714 5/23/83
PROCEDURE REVISION REQUEST

E. I. Hatch Nuclear Plant

CONTINUOUS AIR MONITORS MODELS AM-3D AND AM-33-1 OPERATION AND CALIBRATION

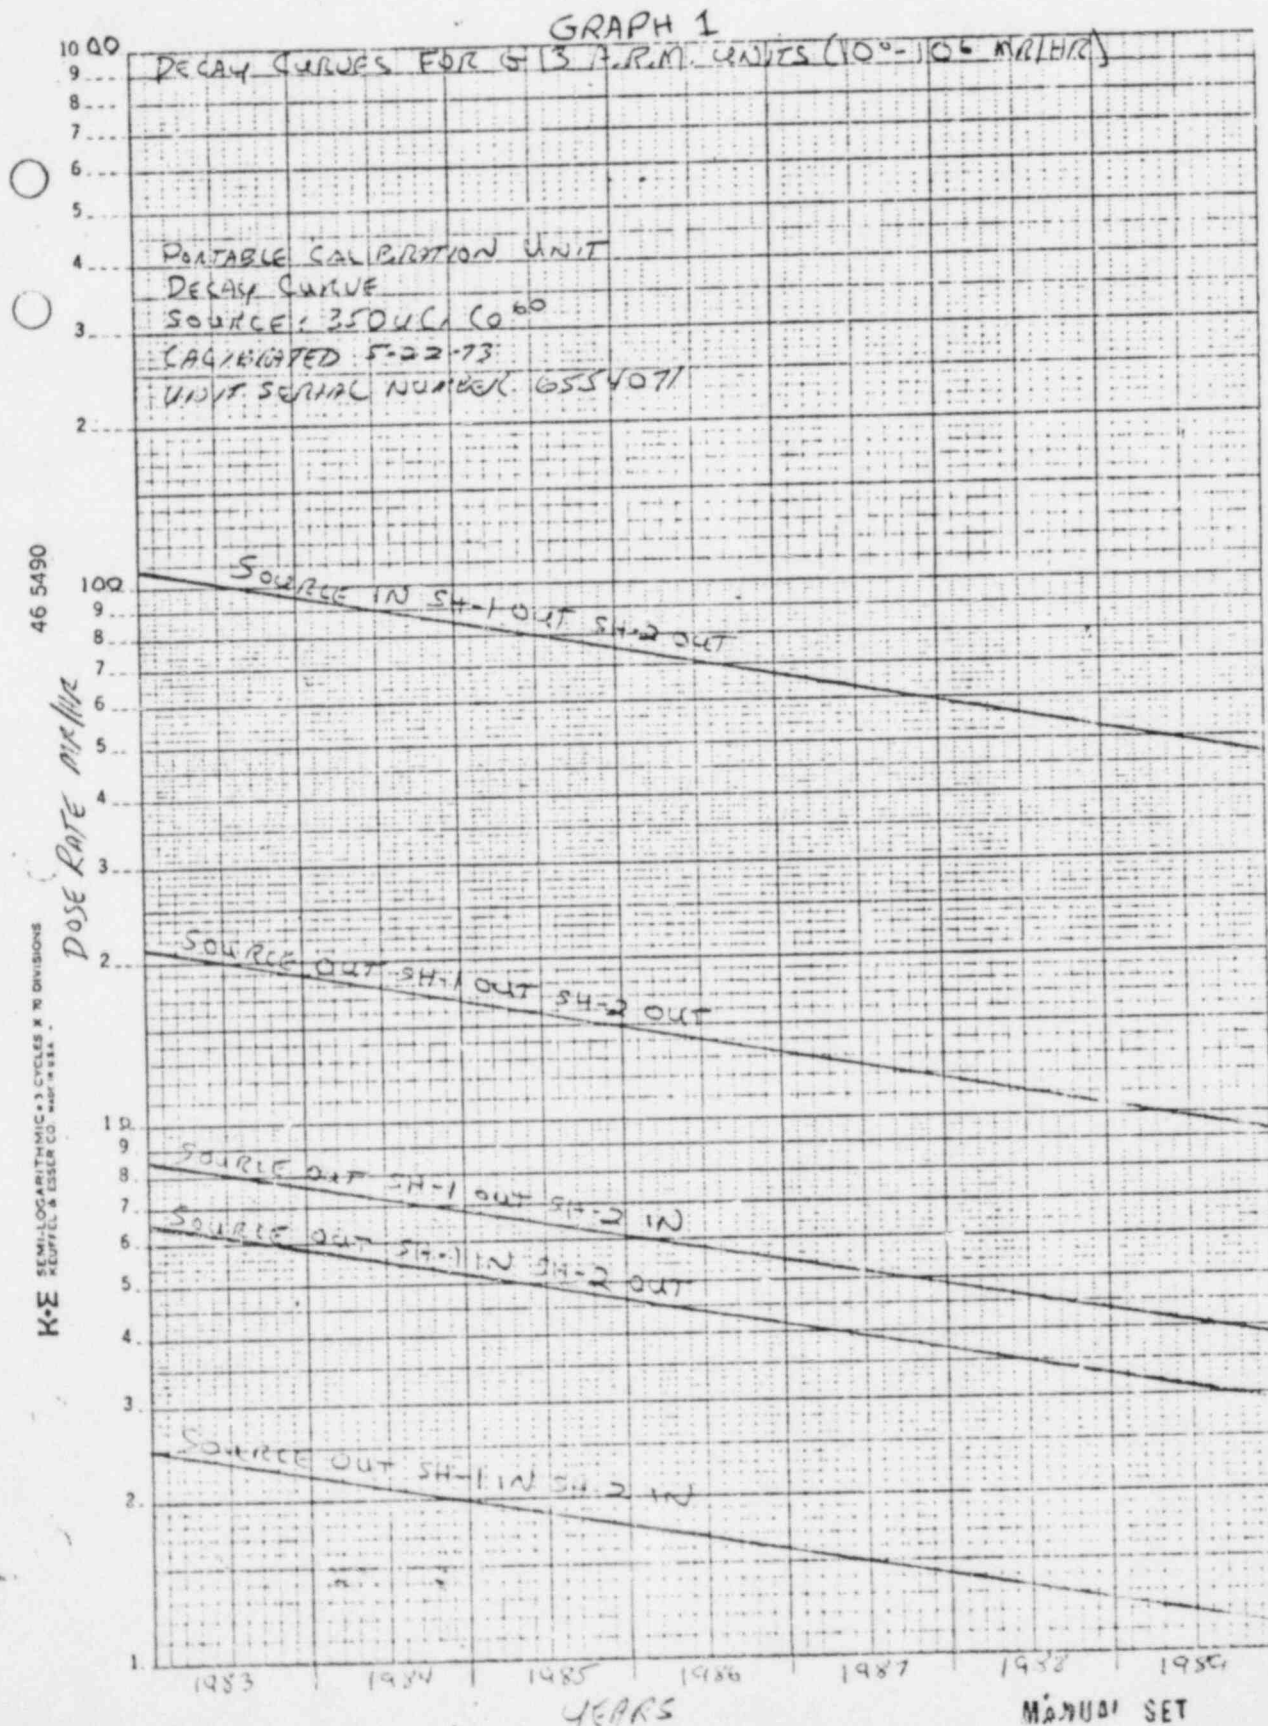
PAGE 4 GRAPH NUMBER ONE DELETE GRAPH, ADD
NEW PAGE 4 GRAPH 1. PAGE 5 GRAPH NUMBER TWO DELETE GRAPH, ADD
NEW PAGE 5 GRAPH 2. PAGE 7 GRAPH NUMBER 3 DELETE GRAPH, ADD NEW
PAGE 7 GRAPH 3. PAGE 8 GRAPH NUMBER 4 DELETE GRAPH, ADD NEW
PAGE 8 GRAPH 4. PAGE 6 FIGURE 1 ADD SERIAL NUMBER
6339537 CHANGE FIGURE 1 TO FIGURE TWO
